Pioneer Grille Surround Trim

Release: 2**Technician Skill Level:** C**Revision Note:** Updated image/Clip quantity**Market:** North America**Service Category:** Service Department**Applicability:** Please refer to VDA+**Section:** Function Group 823

Certain model PR's could experience grille surround trim detaching due to insufficient retention.

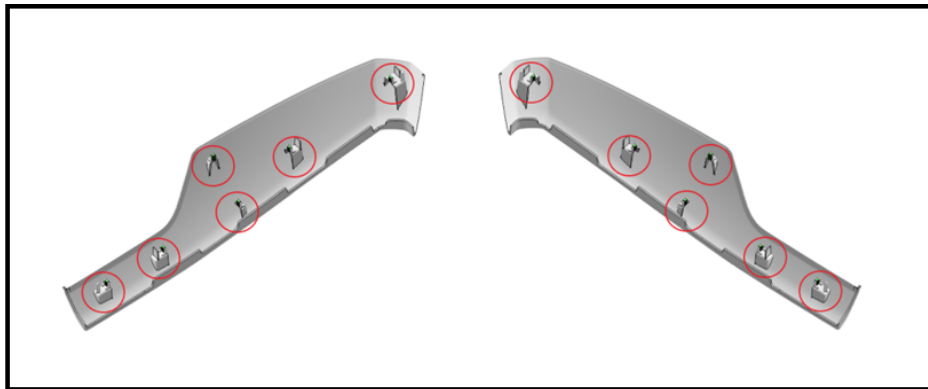
6. Using the image below, install new adhesive pieces in the locations shown.

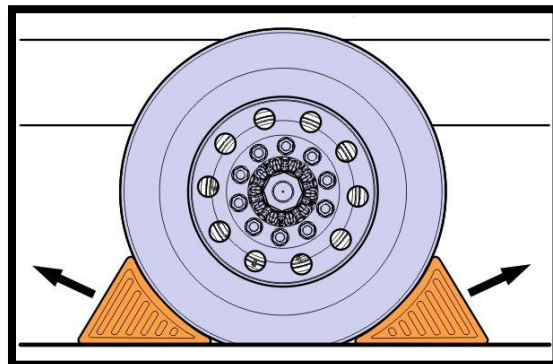
7. Install new spring clips (PN: 78514615) on the trim.
